PETITION FOR VARIANCE
15th Election District

RE: PETITION FOR VARIANCES : BEFORE THE ZONING COMMISSIONER
NE/S of North Point Blvd.
476' SE of Rosebank Ave.
(3862 North Point Blvd.) : OF BALTIMORE COUNTY
15th District :
JOSEPH J. PIROG, JR., : Case No. 86-92-A
et ux, Petitioners

SITE PLAN	
for VARIANCE PETITION	
Proposed Addition to	
WALTER JAY'S AUTO PAINT	
3862 NORTH POINT BLVD	
BALTO. MD. 21222/Elect Dist 15	
Scale: 1" = 50'	Date: 5/10/85
BY: G. D. McLELLAN & ASSOC.	4/1-9136

SITE PLAN
 for VARIANCE PETITION
 Proposed Addition to
 WALTER JAY'S AUTO PAINT
 3862 NORTH POINT BLVD
 BALTO., MD. 21222/Elect Dist. 15
 scale: 1" = 50' date: 5/10/85
 BY: G. D. McFILLAND & ASSOC. 4/1-9136

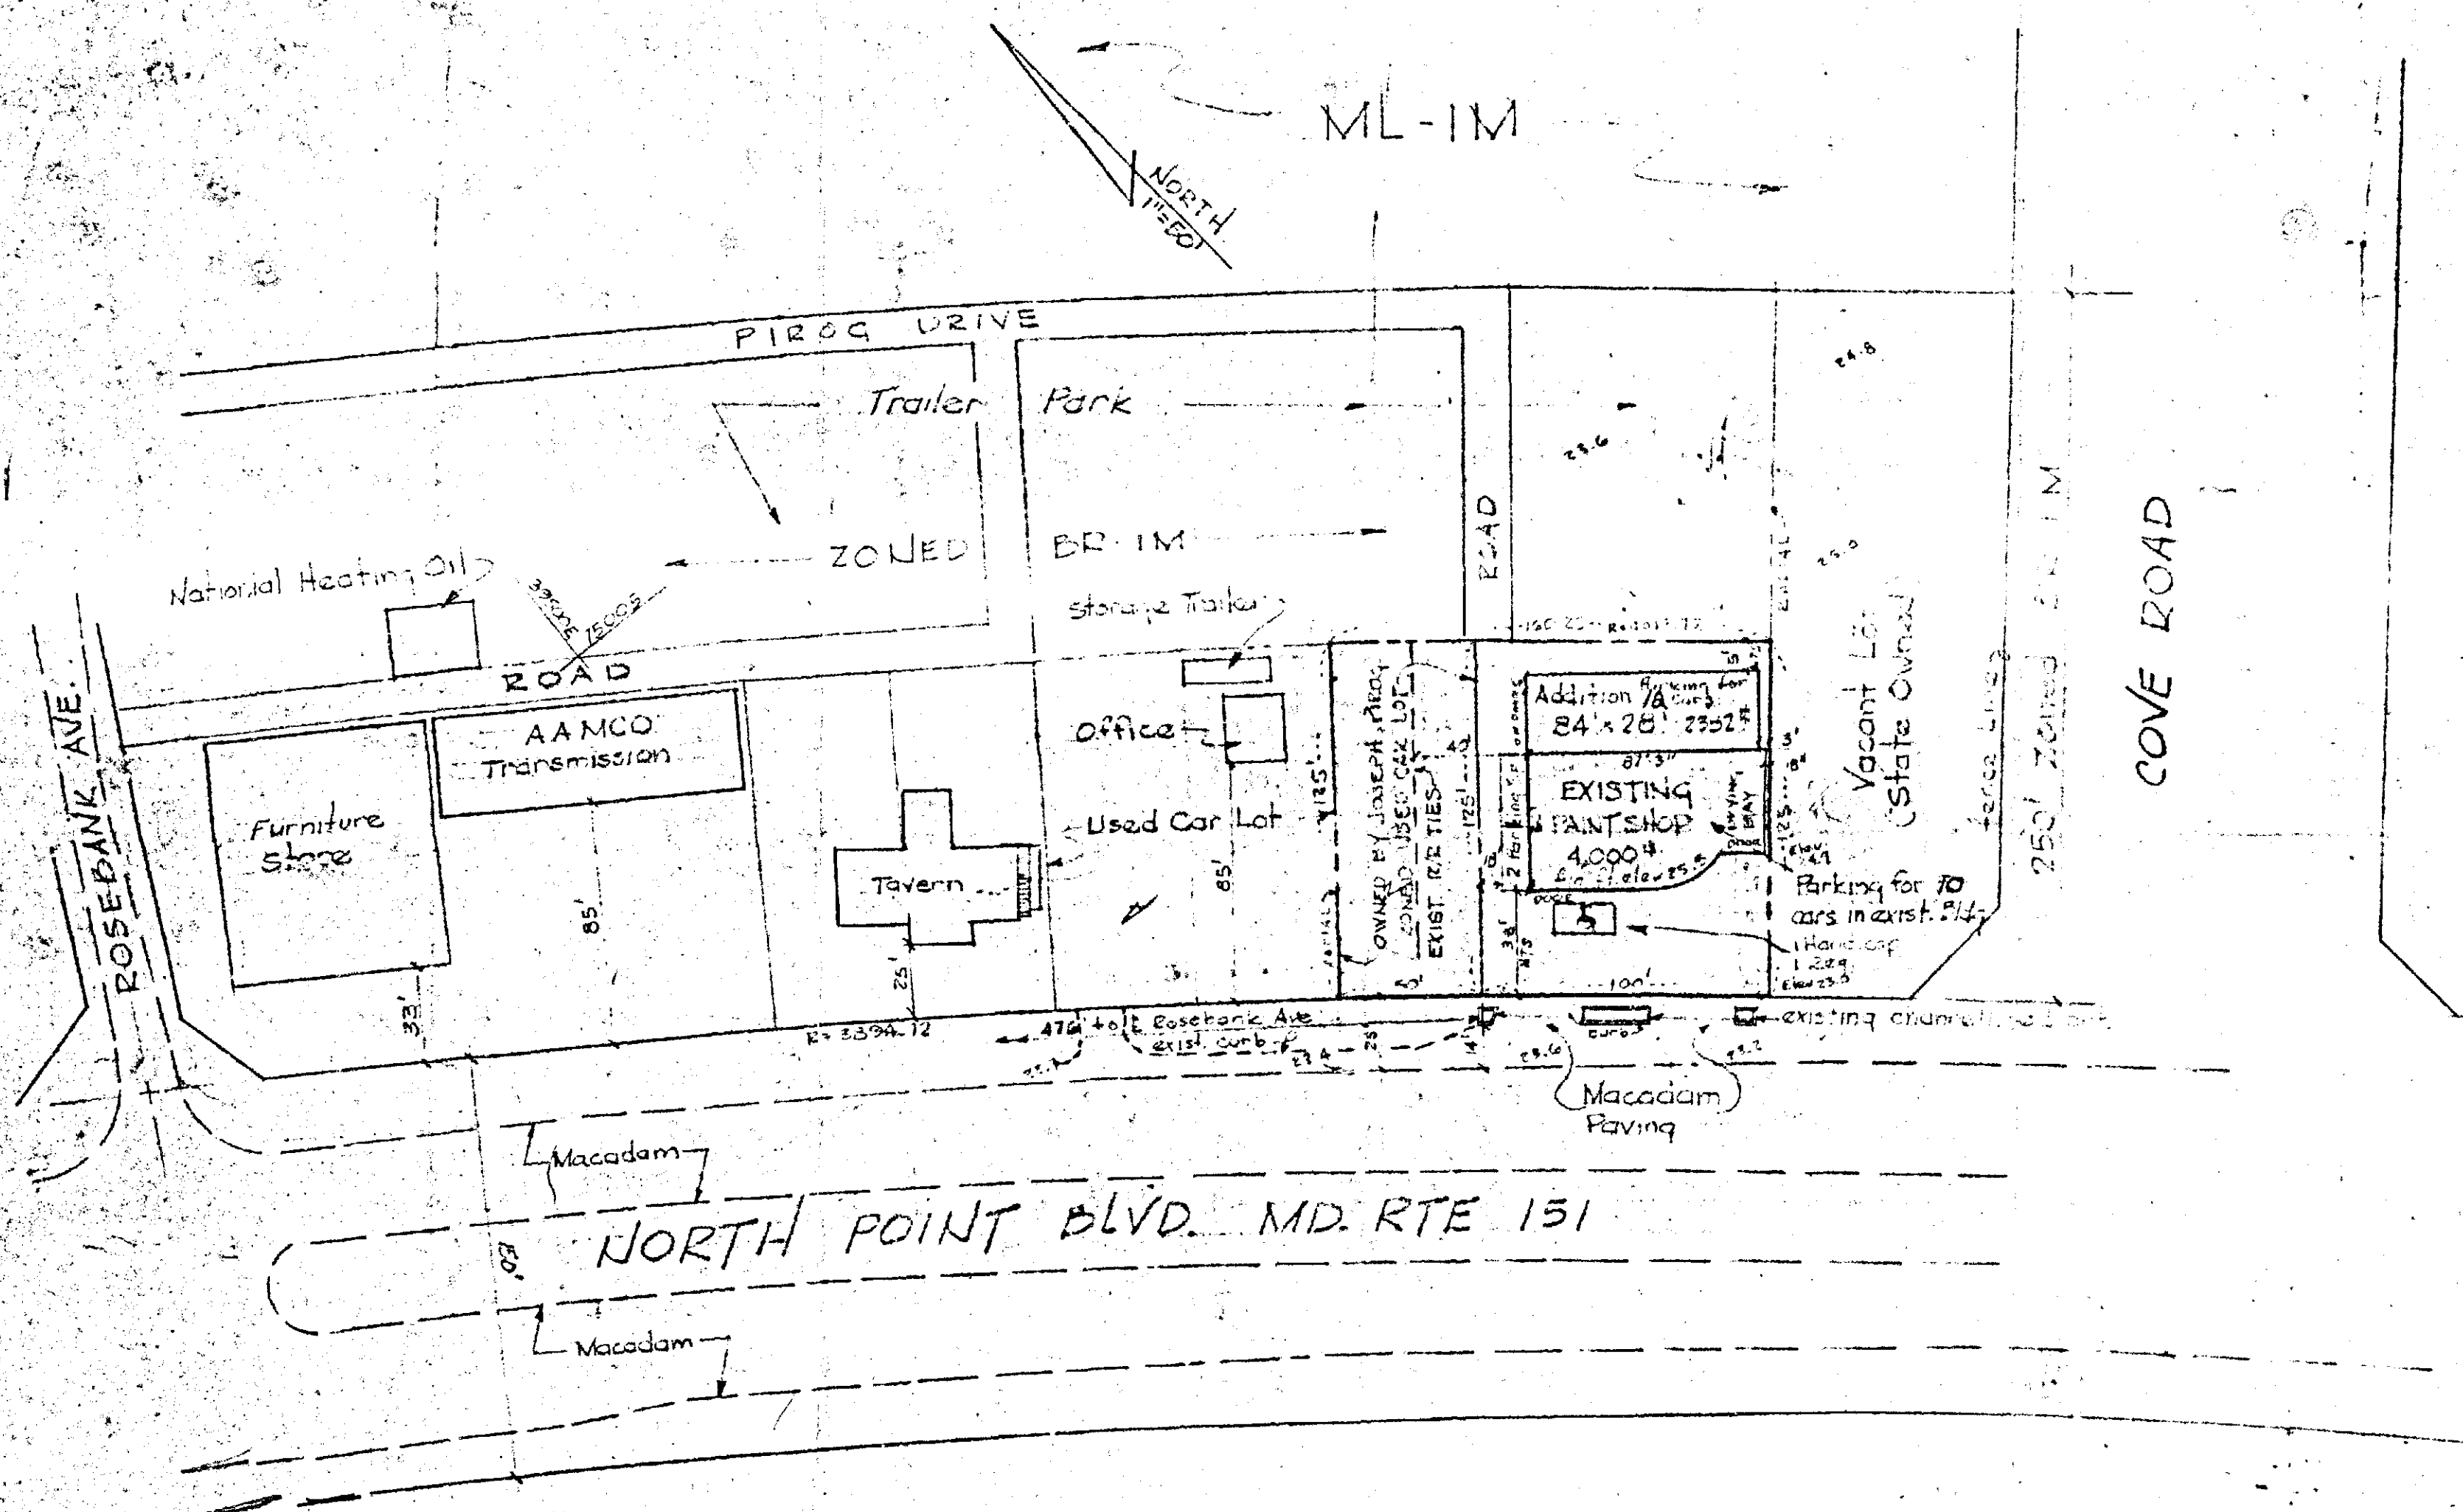
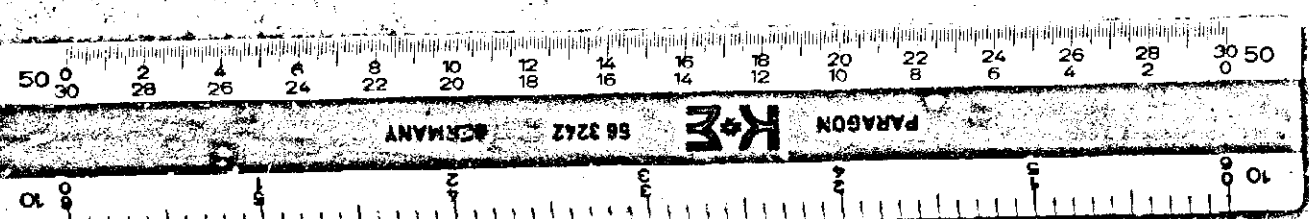
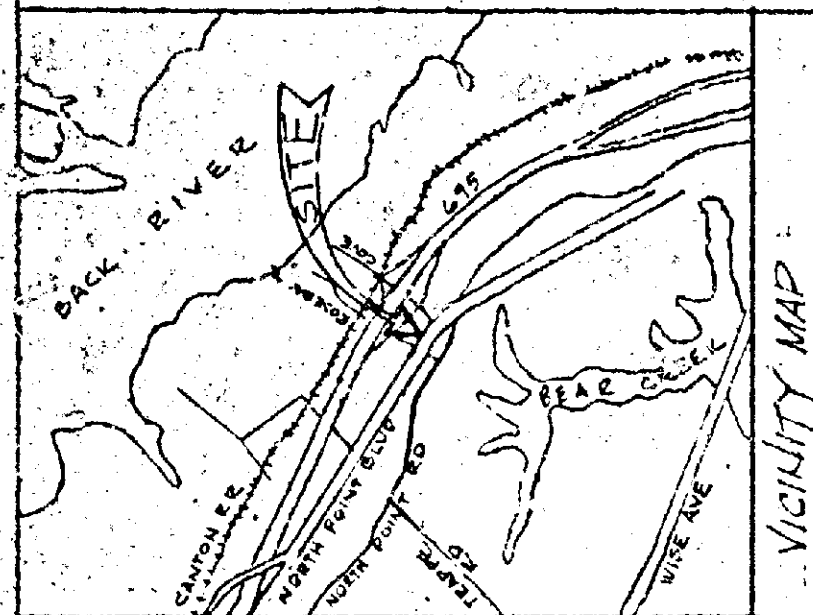
3. Hours of operation shall not extend beyond 7:30 a.m. and 6:00 p.m.
4. All requirements of the Baltimore County Landscape Manual shall be met. Live evergreen screening to reach a height of 10 feet within 4 years shall be planted between the addition and the rear property line. Landscaping shall be added to the front of the building.

7. No access from the site to the state-owned land to the southeast shall be allowed unless there is an approved site plan for the state land on file with Baltimore County and unless the lot has been completely developed in accordance with that plan.

8. A drawing of the interior of the existing building and the addition showing bulky and permanently attached equipment, as well as parking spaces, shall be submitted to and approved by the Office of Zoning prior to the issuance of building permits. Access to the building and addition shall be granted to county inspectors to insure that indeed such parking spaces are available.

9. All parking spaces shall be striped. Parking in areas not indicated as parking spaces on the approved plan shall constitute a zoning violation in that it will be non compliance with an approved site plan.
